RESOLUTION NO. 12-02

RESOLUTION OF THE TOWN OF ST. LEO TOWN COMMISSION APPROVING
SAINT LEO UNIVERSITY INC., SOCCER/LACROSSE FIELD AND PARKING
GARAGE SITE PLAN/VARIANCE REVIEW (SPR/VAR #11-F) WITH CONDITIONS.

**SITE PLAN (SPR)/VARIANCE (VAR) REVIEW STAFF REPORT
SPR/VAR#11-F: Saint Leo University Soccer/Lacrosse Field and Parking Garage
Town Commission Meeting October 10, 2011**

PREPARED FOR: TOWN OF SAINT LEO
 PROJECT: SOCCER AND LACROSSE FIELD
 DATE: 02/03/2016
 DRAWING NO.: SP-016
 SHEET NO.: 0203.00

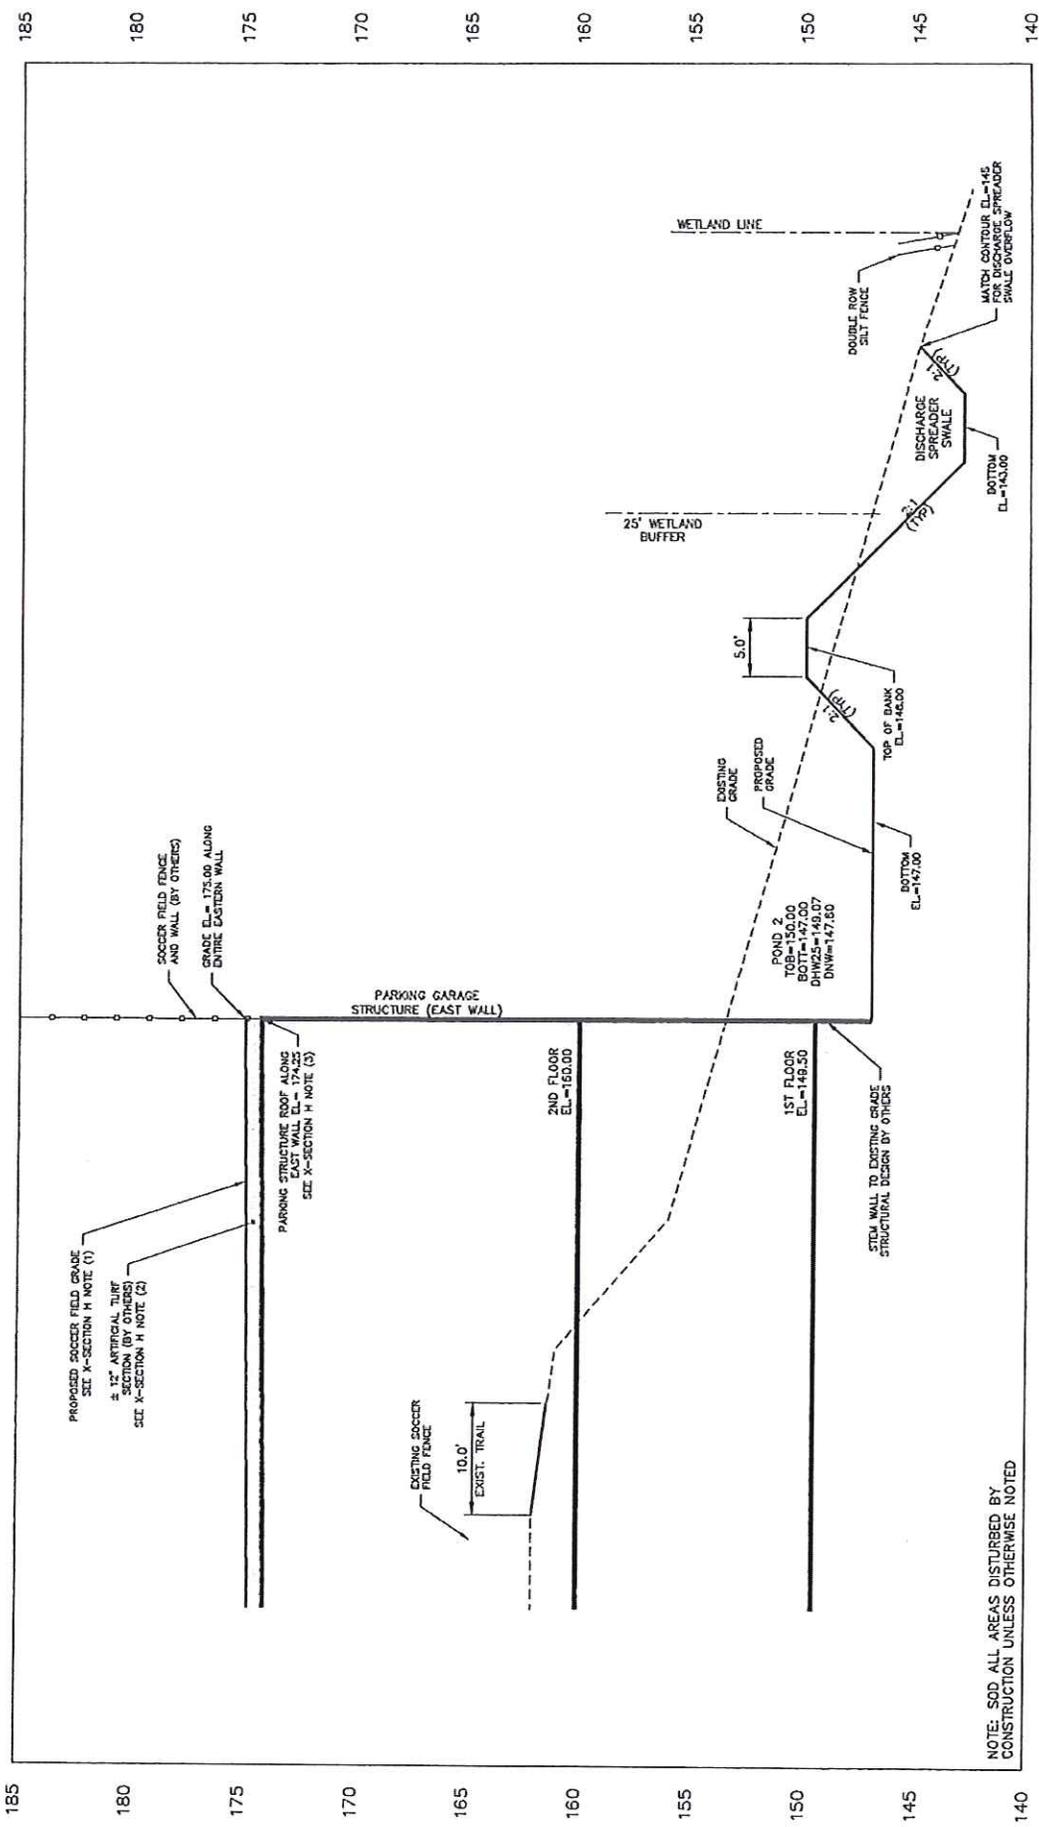
Pursuant to the LDC (Sec. 7.11. Special Requirements for Environmentally Sensitive Areas and Historic Resources) a twenty-five (25) foot setback is required from wetlands, forested and wildlife habitat areas. Although there is no physical encroachment of the project into the wetland, the project does not meet the setback requirement. The parking garage frontage adjacent to the wetland area (not the actual meandering wetland boundary line) is a straight line 515+/- feet in length. Appendix A- Sheet SP-016 illustrates the setbacks. The Applicant is requesting the following variances:

1. To permit a parking garage setback of less than twenty-five (25) feet from the Environmentally Sensitive Land boundary for approximately a distance of 196 linear feet. Within the 196 feet, at its closest point, there will be an approximate six (6) to ten (10) foot parking garage setback from the Environmentally Sensitive Land boundary for a distance of approximately 170 linear feet. It is noted that for approximately another 319 linear feet, the parking garage setback is greater than twenty-five (25) feet.

The buffer encroachment represents 38 percent of the parking garage frontage along the wetland.

2. To permit a stormwater pond (top of bank) setback of less than twenty-five (25) feet from the Environmentally Sensitive Land boundary for its entire length (a straight line of approximately 255 linear feet). At its closest point, there will be an approximate two (2) foot stormwater pond setback from the Environmentally Sensitive Land boundary. It is noted that the stormwater pond setback ranges from two (2) feet to thirteen (13) feet. SWFWMD requires that an average twenty-five (25) foot buffer be provided with a minimum setback of fifteen (15) feet. Stormwater ponds are not exempt from this SWFWMD rule.

The pond frontage relative to the entire wetland area frontage (515 feet) paralleling the project is 49.5 percent.

X-SECTION C

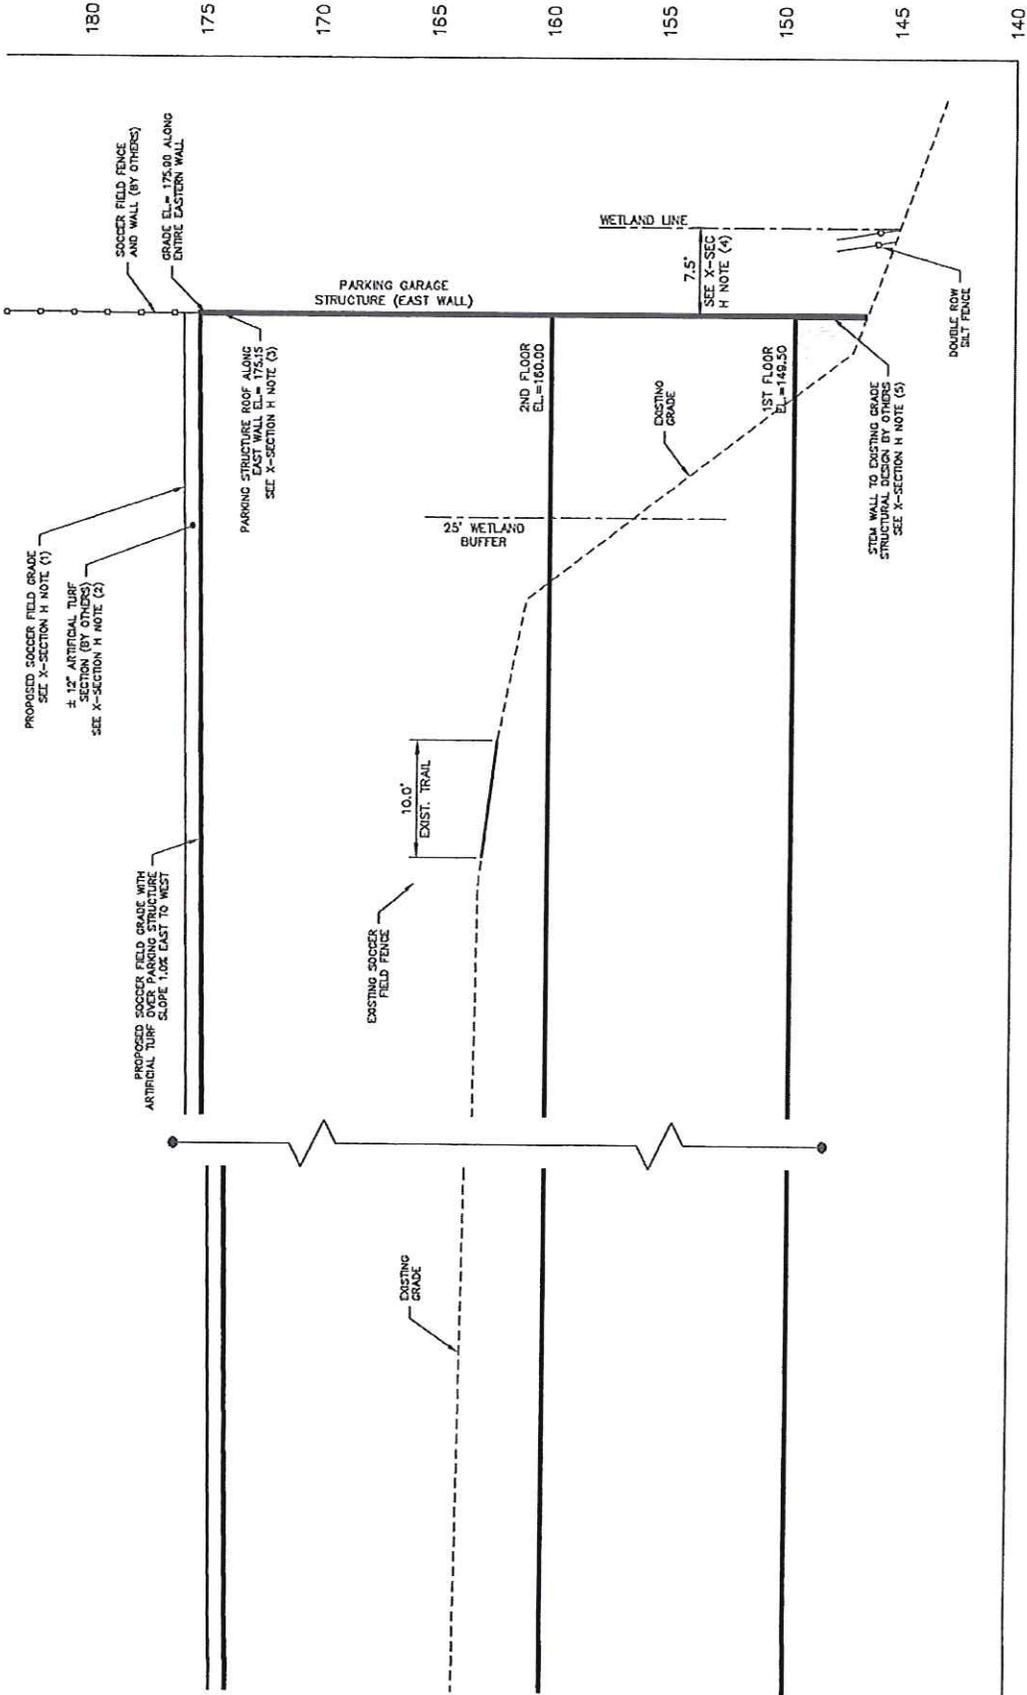
Based on the cross sections provided by the Applicant, there is a significant existing grade change (18+/- feet) from the eastern edge of the existing soccer field to the wetland. This grade change occurs over a distance of 56+/- feet at the northeast corner of the site (Appendix A, Cross Section H) and over a distance of 116+/- feet at the central portion of the site (Appendix A, Cross Section C). The grade change from the proposed garage at the northeast corner to the wetland will be 2+/- feet for a distance of 7.5+/- feet and at the central portion a grade change of 4+/- feet for a distance for 70 +/- feet. The project will entail fill for the new garage and leveling of the grade to reduce the large existing change in grade to the wetland and provide for a stormwater pond; therefore, the requested encroachments are required.
